Rebuttal Report of Christian R. Petrich

In the Matter of Application for Transfer No. 73811 (Shekinah Industries); Application for Transfer No. 73834 (Orchard Ranch); Application for Permit No. 63-32499 (Mayfield Townsite); Application for Permit No. 61-12095 (Nevid-Corder); Application for Permit No. 61-12096 (Nevid); Application for Permit No. 63-32703 (Orchard Ranch); Application for Permit No. 61-12256 (Intermountain Sewer & Water); Application for Permit No. 63-33344 (ARK Properties-Mayfield Townsite) before the Idaho Department of Water Resources

January 30, 2013

Figure 1. Inferred groundwater flow directions at study-area boundaries.

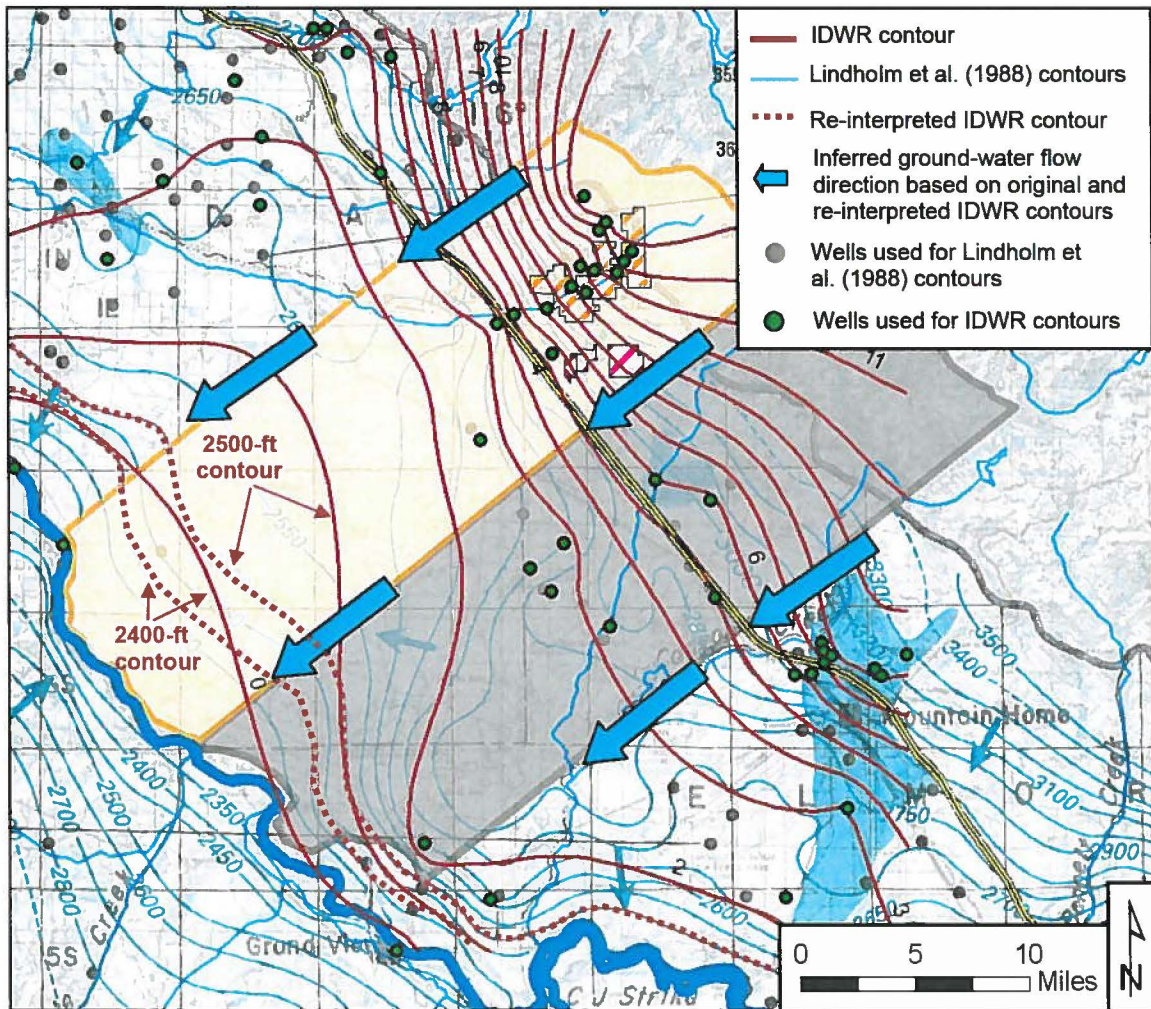
1. *ERO argues that the “size and location of the study area are arbitrary and not supported by technical analysis” (ERO, page 14).*

That said, the southwest-northeast study-area boundaries are not entirely perpendicular to IDWR’s groundwater-level contours (see Figure 4 of the IDWR Staff Memo) in the southern portion of the study area. As such, the study boundaries appear to not be aligned along regional flow lines in this area. However, Lindholm et al. (1988) defined regional groundwater-level contours using a much larger (and more regional) data set. Figure 1 shows (a) Lindholm et al.’s groundwater-level contours, (b) IDWR groundwater-level contours presented in Figure 4 of the IDWR Staff Memo, and (c) IDWR water-level contours that SPF reinterpreted based on the previous Lindholm et al. contours. Inferred groundwater flow lines based on the IDWR contours and Lindholm et al. regional groundwater-level contours represent a reasonable basis for IDWR’s southwest-northeast study-area boundaries.

Response. The study area designated by IDWR for evaluating groundwater supply is appropriately sized and technically defensible. The study area encompasses all of the proposed points of diversion and proposed places of use. The study area is defined by defensible boundaries.

The up-gradient boundary was defined as a surface-water flow divide (e.g., the ridge separating the Snake River and South Fork Boise River drainages). Similarly, the down-gradient boundary was established at the Snake River, which clearly is a groundwater-flow divide based on regional groundwater-level contours (Lindholm et al., 1988). There does not appear to be any disagreement regarding the use of these up-gradient and down-gradient boundaries.

The southwest-northeast study-area boundaries are based on groundwater flow lines. Groundwater flow lines can be used to represent no-flow hydraulic boundaries (Anderson and Woessner, 1992), as long as cones of depression from the proposed pumping do not substantially impact groundwater levels at the boundary. In this case, there is no evidence that existing pumping inside or outside of the study area has materially impacted groundwater levels within the study area.

Figure 2. Surficial geology in the vicinity of the upper Blacks Creek drainage.

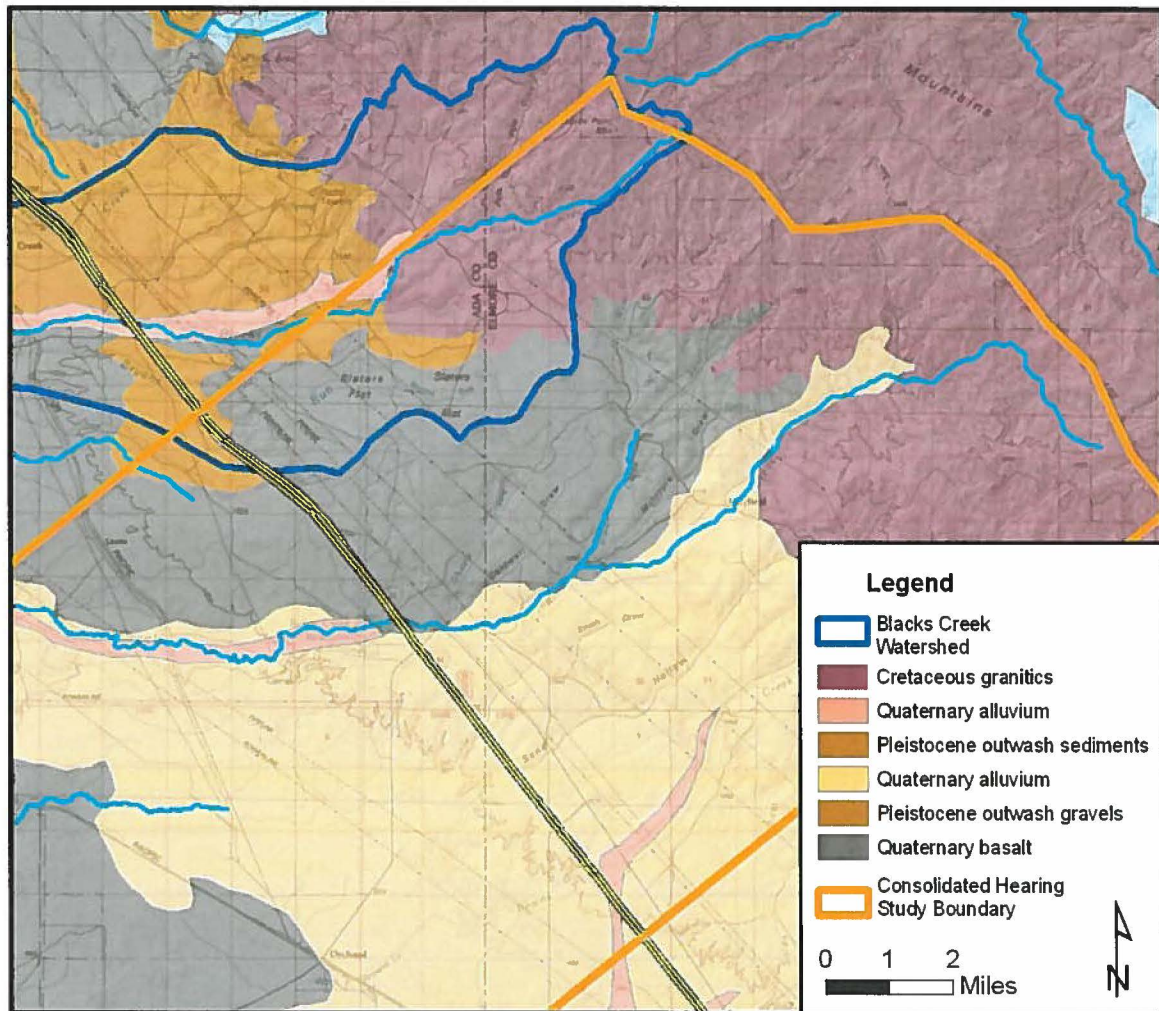
8. *ERO states that "inclusion of a portion of the Blacks Creek drainage in the area used for the recharge estimate is an unwarranted complication in the water budget because there is no information indicating the direction of groundwater flow in the Blacks Creek basin is different than observed regionally" (ERO Report, page 15).*

Inclusion of a portion of the Blacks Creek drainage within the consolidated cases study area is not, in my view, an unwarranted water-budget complication. On the contrary, it is only reasonable to assume that groundwater flow within the study area remains within the study area.

The general direction of groundwater flow from this portion of the Blacks Creek drainage is towards the southwest (see Figure 4 in the IDWR Staff

Memo). Alluvial sediments at the granitic bedrock contact (Figure 2) provide a pathway for downward groundwater movement along flow lines in Figure 4 of the IDWR Staff Memo toward deeper sedimentary zones. Similarly, infiltration into granitic joints and fractures in upper portions of the Blacks Creek drainage also likely migrates basinward within study boundaries, as illustrated in Figure 18 of the Welhan report (Welhan, 2012).

Figure 3. Locations of wells in the upper Blacks Creek drainage with groundwater-level data.

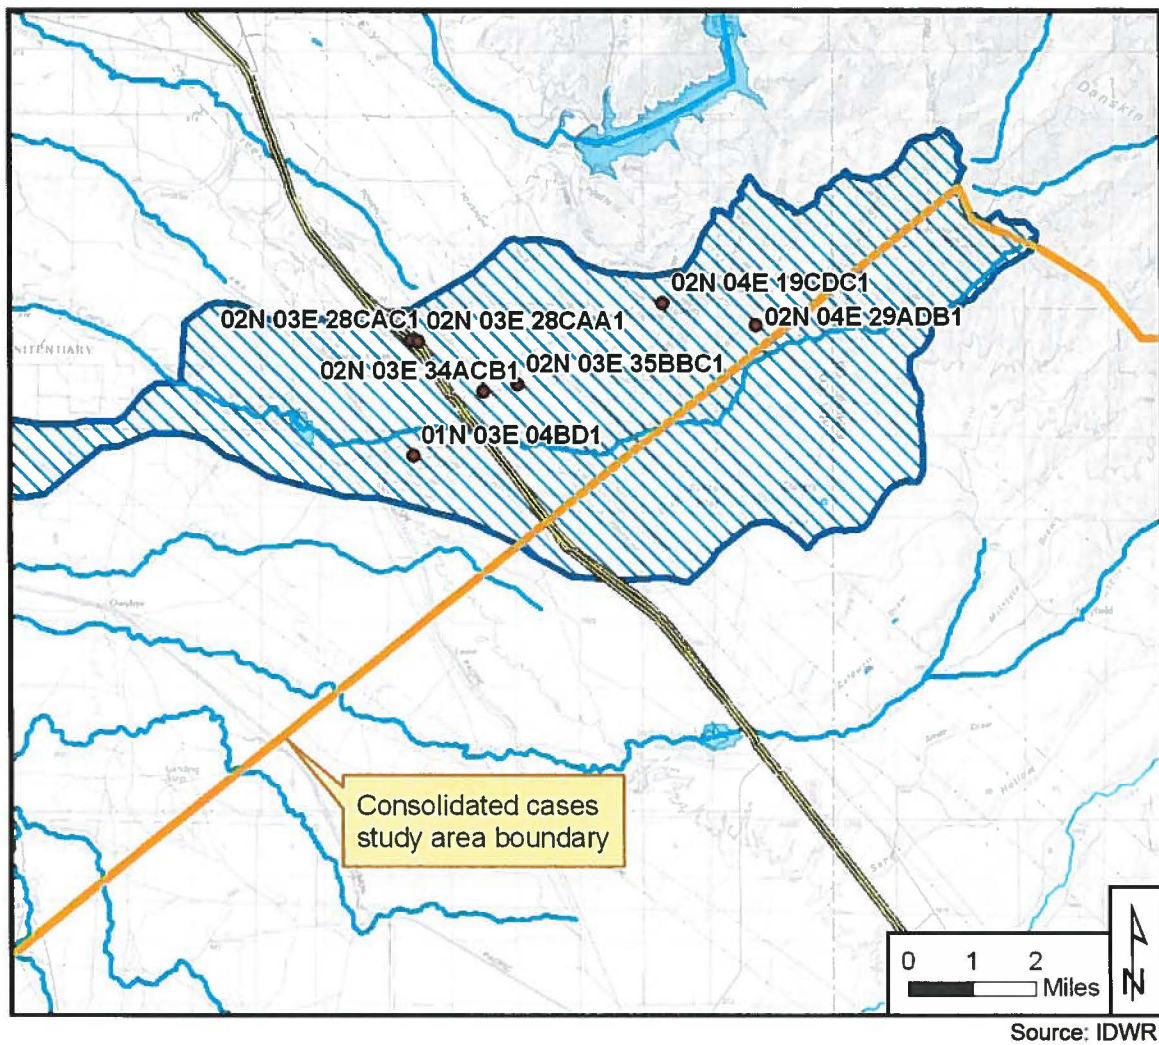
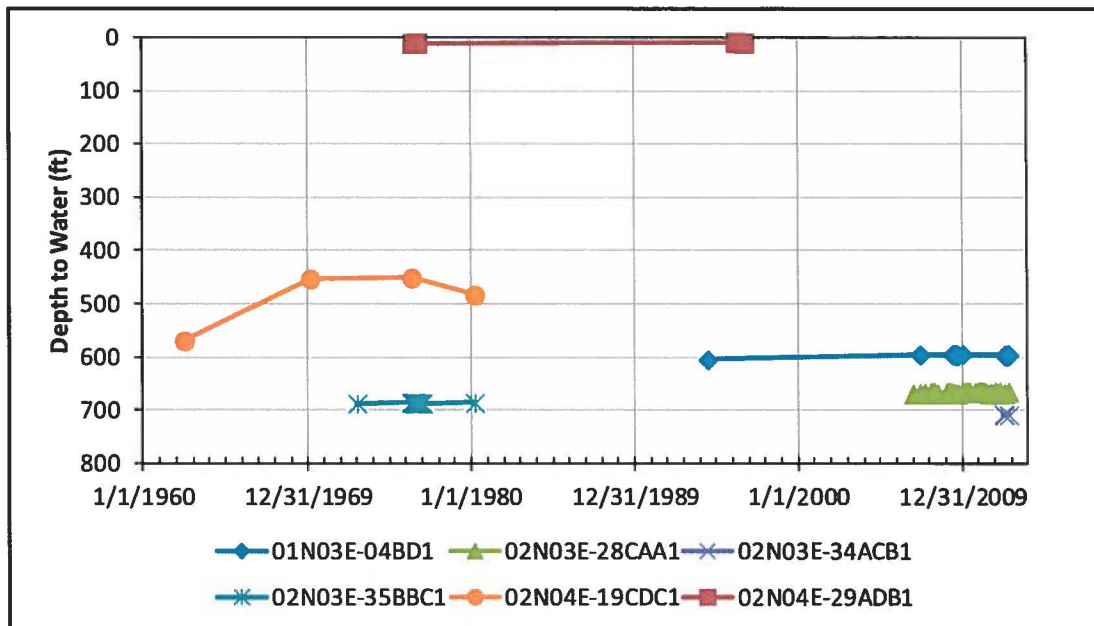
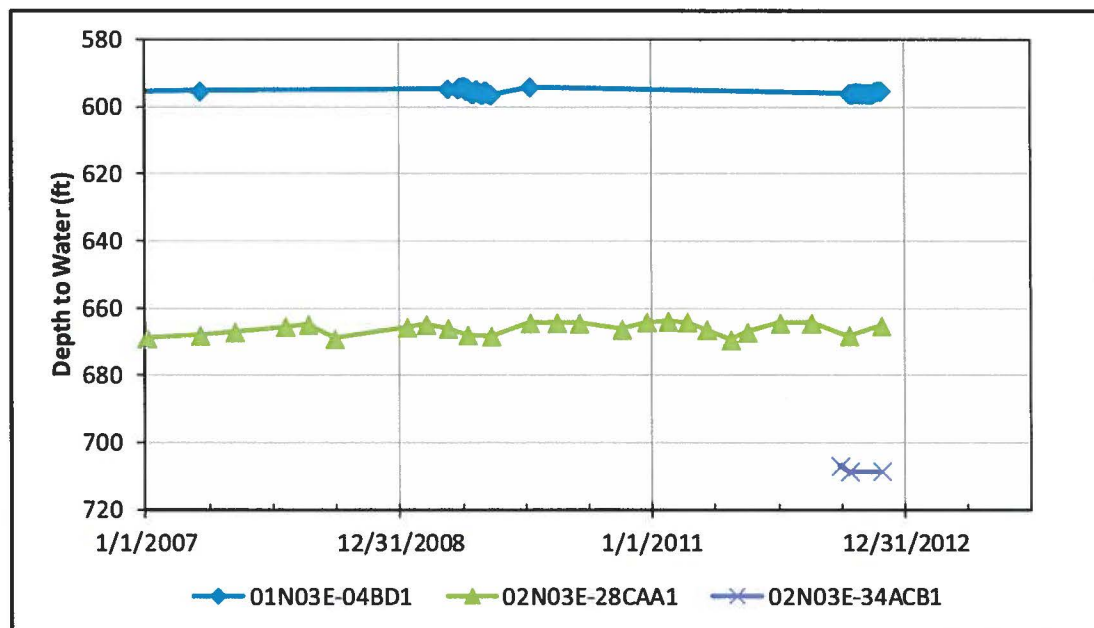
9. ERO also argues that "long-term effects of pumping in the Blacks Creek drainage just outside of the study area" should be included in IDWR's analysis (ERO Report, page 15).

The only water right within the upper Blacks Creek drainage near the study-area boundary authorizing substantial diversions is water right 63-11540, which authorizes a maximum diversion of 3.1 cfs for the irrigation of 287 acres approximately 2.5 miles outside of the study-area boundary. This water right was fully exercised by 2006 (permit proof was made on September 29, 2006), and the right was licensed on November 1, 2010. There is no evidence that pumping under this right has or will create regional groundwater-level declines.

Locations of wells in the upper Blacks Creek drainage with publicly-available groundwater-level data are shown in Figure 3. Hydrographs from these wells (Figure 4 and Figure 5), including a well within ¼-mile from the point of diversion for water right 63-11540, show no groundwater-level declines, indicating that diversions authorized under water right 63-11540 have not created (and therefore likely will not create) groundwater-level declines in the upper Blacks Creek drainage area. Thus, it appears that ERO's concerns about long-term effects of pumping outside this portion of the study area are unfounded.

Figure 8. Portion of "non-recharge area" from which recharge capture is likely.

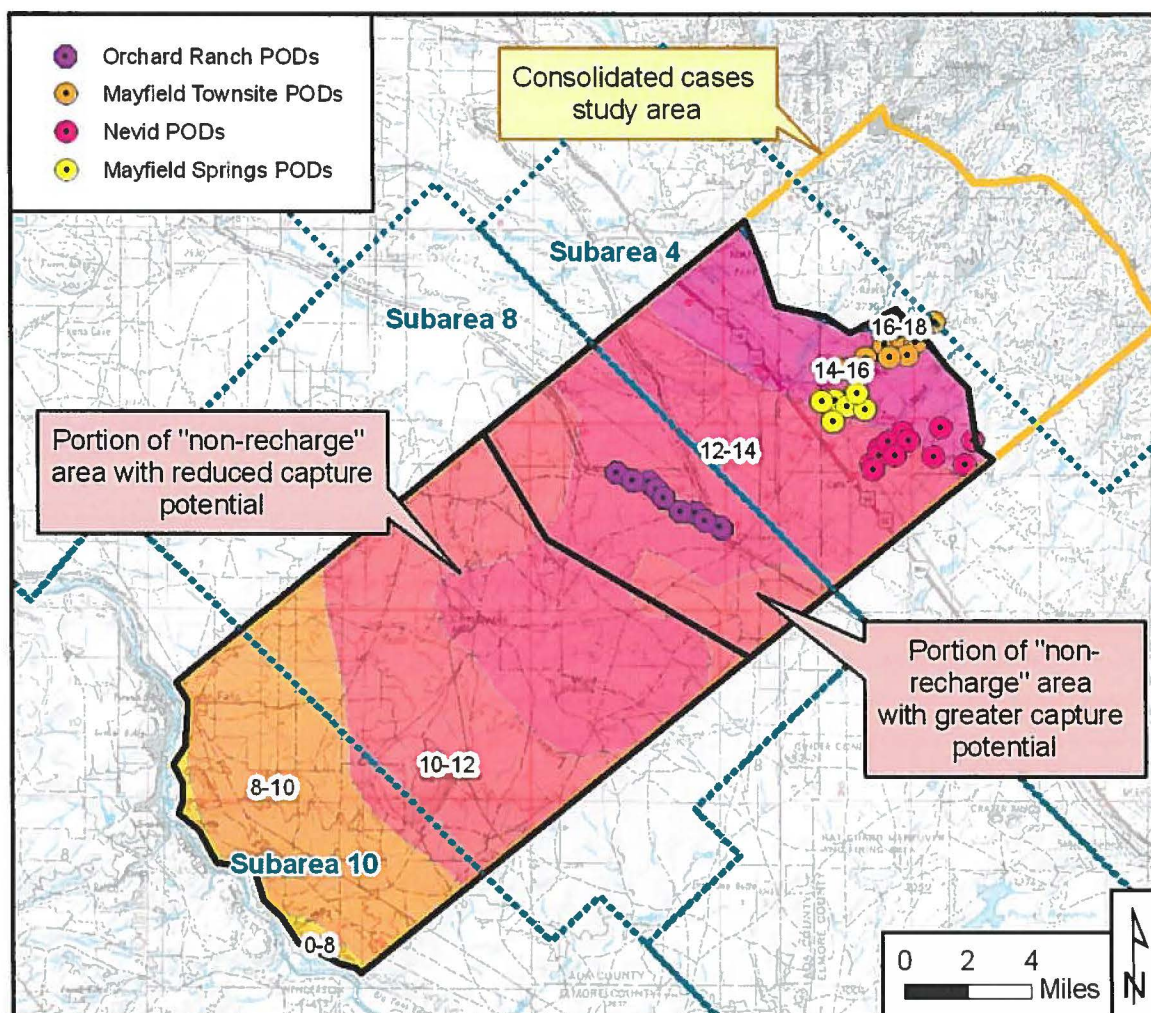
Response, Part 3: ERO maintains that portions of the non-recharge area are “outside of and down gradient of the ‘reach’ of the proposed wells” (ERO Report, page 16). However, there is no basis for concluding that recharge from the entire “non-recharge” area cannot be captured. On the contrary, it is quite likely that wells proposed under pending applications/transfers can capture recharge originating as precipitation infiltration within the northern portion of the “non-recharge” area.

Figure 8 illustrates a portion of the “non-recharge” area with greater potential of capturing recharge originating from the “non-recharge” area and an area with reduced capture potential. The line separating these two portions of the “non-recharge” area is approximately 3 miles down-gradient of the Orchard Ranch wells, which presumably could develop an approximate 3-mile capture radius.

The amount of average annual recharge generated within the portion of the “non-recharge” area having greater capture potential was estimated using the same estimated USGS recharge percentages (Newton, 1991) and PRISM data that IDWR used in developing a recharge estimate for the “non-recharge” area. Using this approach, the amount of recharge within the portion of the “non-recharge” area having greater capture potential is approximately 1,950 acre-feet per year (Table 1).

Figure 9. Comparison of Newton (1991) model zone locations interpreted by IDWR and SPF.

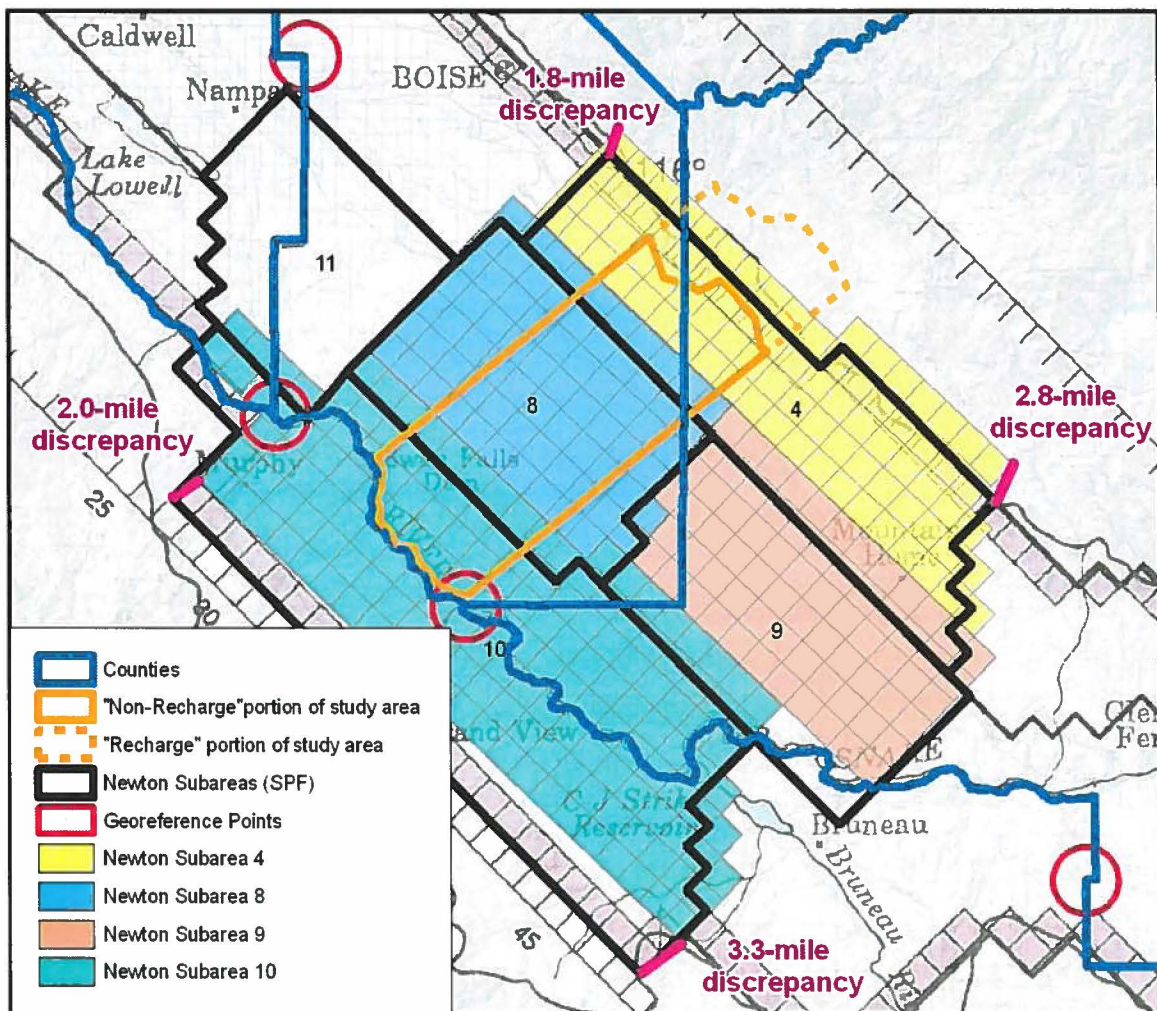
In calculating recharge for the "non-recharge" area using USGS subareas we found a discrepancy in IDWR's geo-referencing of the Newton (1991) subarea map. Correcting this discrepancy resulted in a recharge estimate of 3,000 AF for the "non-recharge" area, which is approximately 340 AF greater than the 2,660 AF recharge volume estimate presented in the IDWR Staff Memo (Table 2).

The geo-referencing discrepancy is illustrated in Figure 9. SPF scanned Figure 17 in the Newton (1991) report and geo-referenced this map using county shapefile polylines (6 points) as reference points. IDWR's geo-referencing was off by distances

of 1.8 to 3.3 miles at four representative corner points (Figure 9). Examples of SPF's geo-referencing points are shown in Figure 10. The net result is that there is a larger portion of USGS subarea 4 and a smaller portion of Subarea 10 in the consolidated cases study area than calculated by IDWR.

Figure 11. Trust area and places-of-use for consolidated applications.

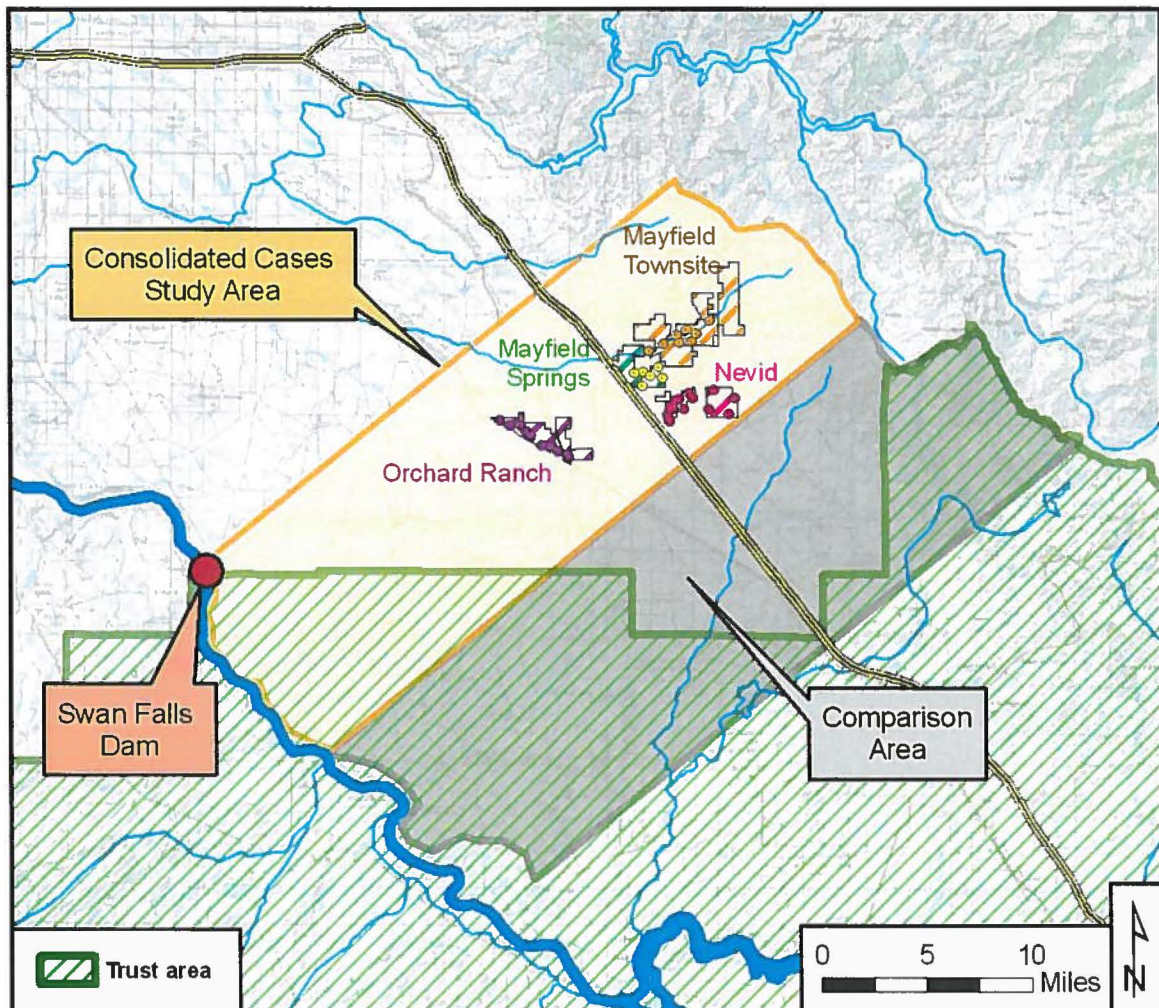
14. ERO notes that “Permits to use ground water have previously been issued to allow the initial phases for two of these projects without regard for trust water impacts” (ERO report, page 2), implying that trust water impacts should have

Points of diversion and places of use for the two referenced permits (63-32225 and 61-12090) are not within the trust area boundary defined under IDAPA 37.003.008 (Figure 11). These applications were not protested based on concerns regarding trust water impacts. Consideration of trust water impacts was therefore not required for the processing of these permits. Furthermore, points of diversion and or places of use for applications that are part of this consolidated administrative process (Applications 63-32499, 61-12095, 61-12096, 63-32703, 61-12256, and 63-33344) also lie outside of the trust area (Figure 11).
